UNITED STATES
NUCLEAR REGULATORY COMMISSION
BEFORE THE ATOMIC SAFETY AND LICENSING BOARD

-----x
In re: Docket Nos. 50-247-LR; 50-286-LR
License Renewal Application Submitted by ASLBP No. 07-858-03-LR-BD01
Entergy Nuclear Indian Point 2, LLC, DPR-26, DPR-64
Entergy Nuclear Indian Point 3, LLC, and
Entergy Nuclear Operations, Inc. June 29, 2012
-----x

**PRE-FILED WRITTEN REBUTTAL TESTIMONY OF
DR. FRANÇOIS J. LEMAY
REGARDING CONSOLIDATED CONTENTION
NYS-12C (NYS-12/12A/12B/12C)**

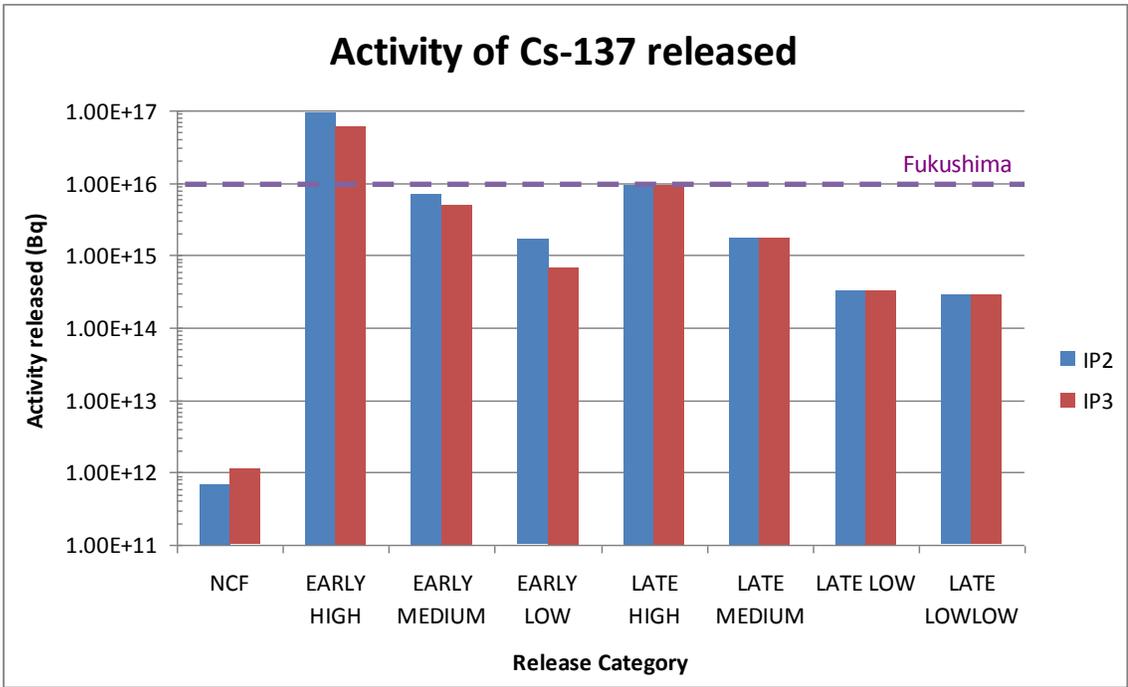
4 A. The bar chart below was created by ISR for this
5 testimony. It shows the activity of Cs-137 released during the
6 Fukushima accident compared to that of each release category
7 used by Entergy (ENT000464).

3 As shown in the chart of the 8 release categories modeled
4 by Entergy, the activity of Cs-137 released at Fukushima is
5 actually six to ten times lower than the activity that Entergy
6 modeled for the simulated release category "EARLY HIGH."

10 A. No. Fukushima is severe, but not worst-case. As I
11 previously explained and as seen on the bar chart, Fukushima
12 fits within the range of severe accidents defined by Entergy.

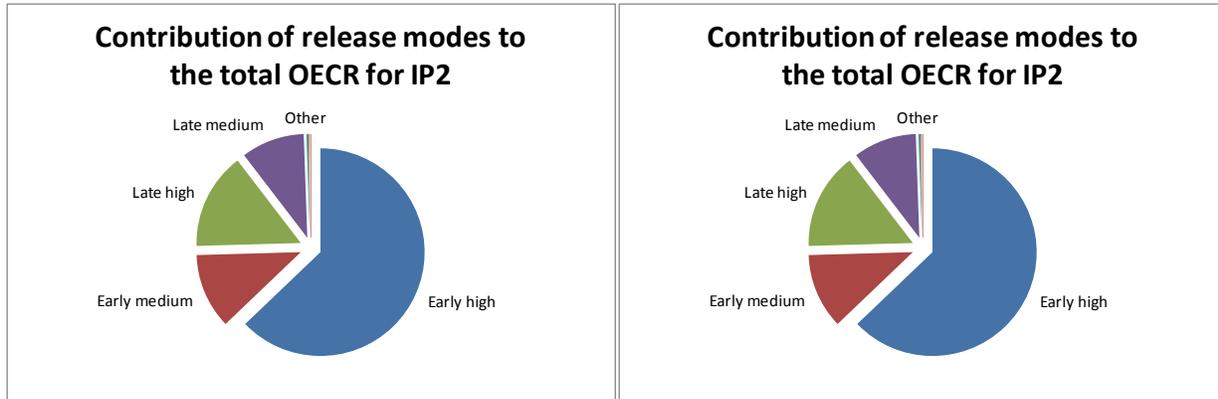
1
 2 As can be seen from the numbers circled in red, release
 3 category "EARLY HIGH" contributes over 60% to the total OECR for
 4 IP2 and IP3. "EARLY HIGH," "EARLY MEDIUM," and "LATE HIGH,"
 5 contribute over 90% to the total OECR.

6 On the other hand, release categories "NCF," "EARLY LOW,"
 7 "LATE LOW," and "LATE LOWLOW" combined contribute less than 1%
 8 to the total OECR for IP2 and IP3.
